4. PLAN COMMISSION CONSIDERATION: Conceptual review and feedback on a rezoning of two (2) vacant parcels from B-3 to M-1 for a proposed 138,705 SF public storage facility (Beyond Self Storage) and other relief from the zoning ordinance. Location: 7830-50 79th Street in Willowbrook, IL 60521

Staff Report to the Plan Commission

Plan Commission Date:	April 3, 2019															
Prepared By:	Ann Choi, Planning Consultant															
Case Title:	Beyond Self Storage															
Petitioner:	NorthPoint Development, LLC (and TCGC Property LLC as property owner) 4825 Lee Avenue, Downers Grove, IL 60515															
Action Requested:	Consideration of a petition for approval of a map amendment to rezone the subject property from the B-3 Zoning District to the M-1 Zoning District, a petition for approval of a Preliminary and Final Plat of Subdivision to consolidate the two-lot property, and consideration of other such relief, exceptions, and variations from Title 9 and Title 10 of the Village Code.															
Purpose:	To develop a three-story, 138,705 square foot self-storage facility.															
Location:	7830-50 79 th Street. Northeast corner of Frontage and 79th, just sout

Exhibit 12 Sidewalk Gap Analysis

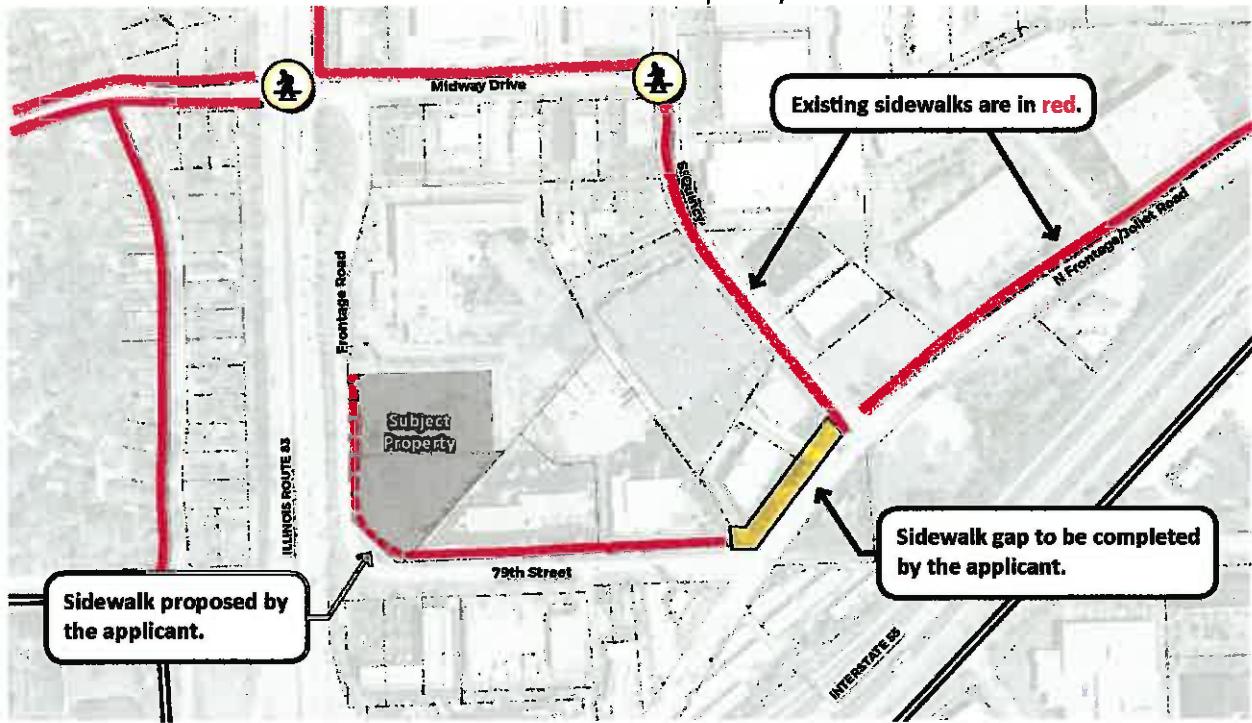
In lieu of installing curb and gutter along the length of the property's frontage, Staff recommends that the petitioner instead shall install sidewalk just southeast of the Quincy Street and Joliet Road intersection, as denoted in yellow in **Exhibit 12** below. The installation of sidewalk in this location will effectively close an existing sidewalk gap and create a continuous pedestrian route from the subject property to the Quincy Street/Joliet Road intersection, and beyond.

UTILITY PLAN

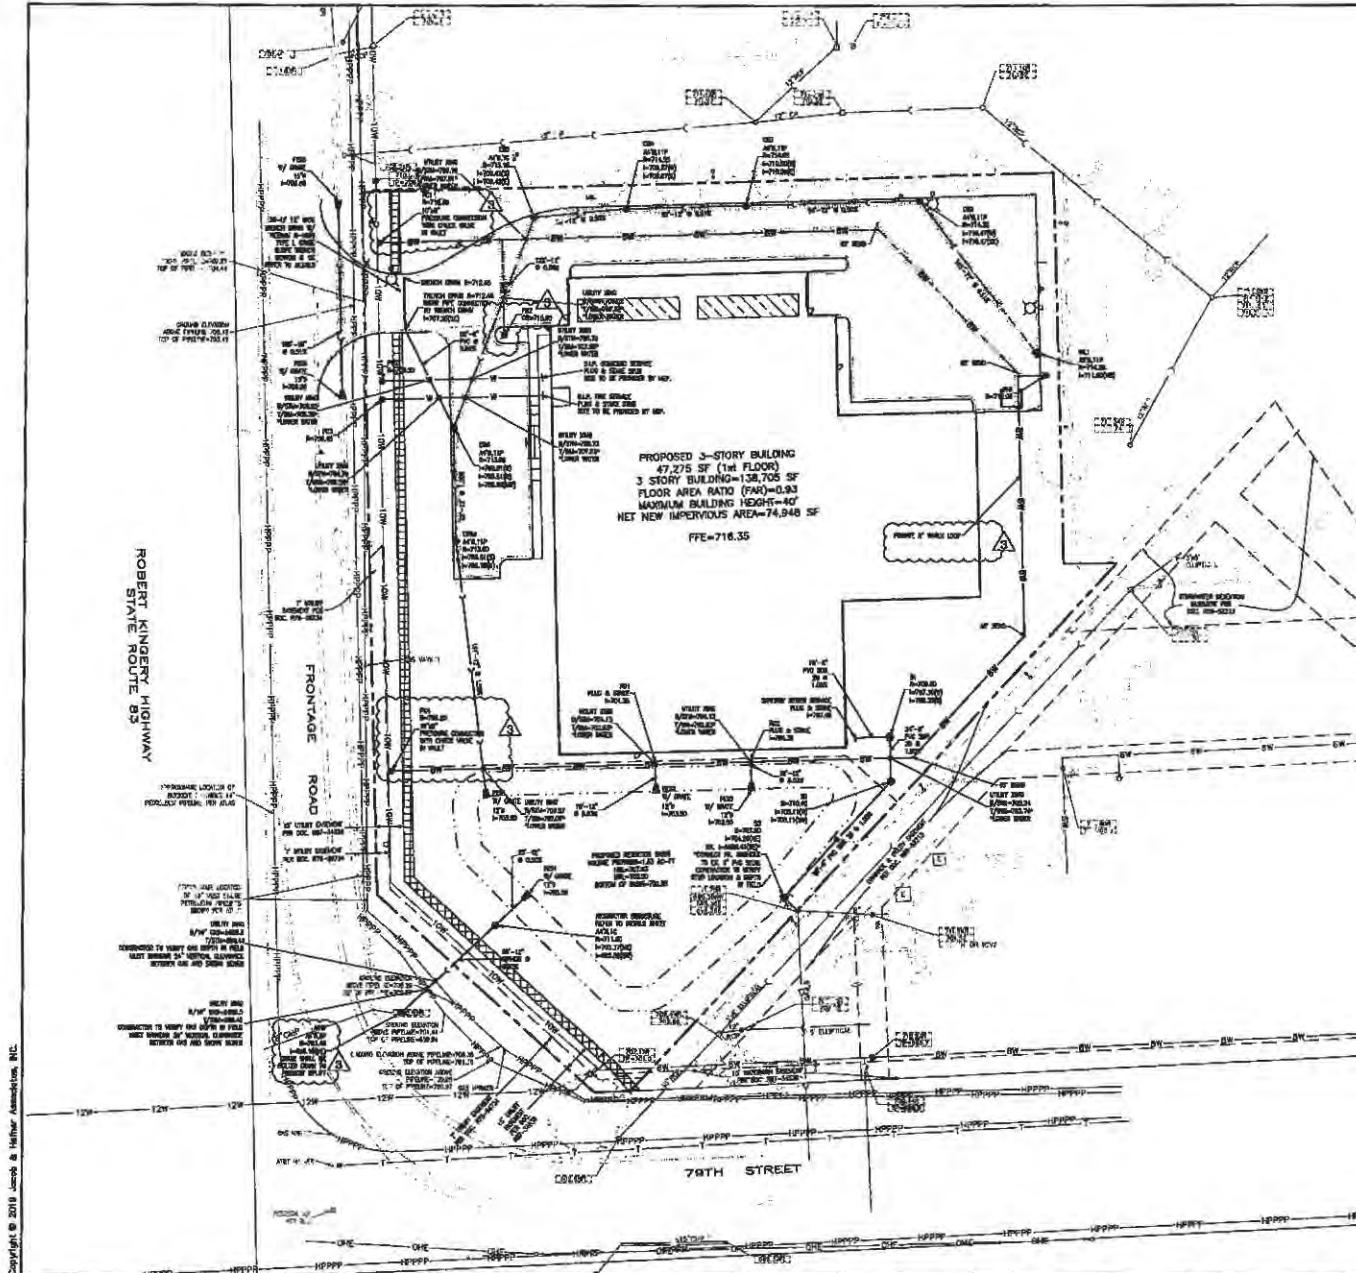
2. **Tri-State Comment:** Add a fire hydrant that is 50' from the Fire Department connection and accessible to the Fire Department. Hydrant distance is greater than allowed. Fire Department is requesting the hydrant to be across from the front entrance by the proposed parking area.

Staff Comment: The petitioner submitted a revised Utility Plan, bearing a revision date of 3/27/2019, and located two fire hydrants near the proposed building. The first fire hydrant, "FH1", is located to the east of the proposed building, adjacent to the trash enclosure. The second fire hydrant, "FH2", is located at the end parking island near the entrance of the building. "FH2" is not within a public utility easement and is thus considered to be a private fire hydrant. "FH2" also conflicts with the location of a proposed shade tree within the end parking island. Staff recommends moving the fire hydrant within the public utility easement or within the public right-of-way, so the Village can maintain and test the hydrants as necessary. Fire hydrant quantities and locations must be approved by the Fire District.
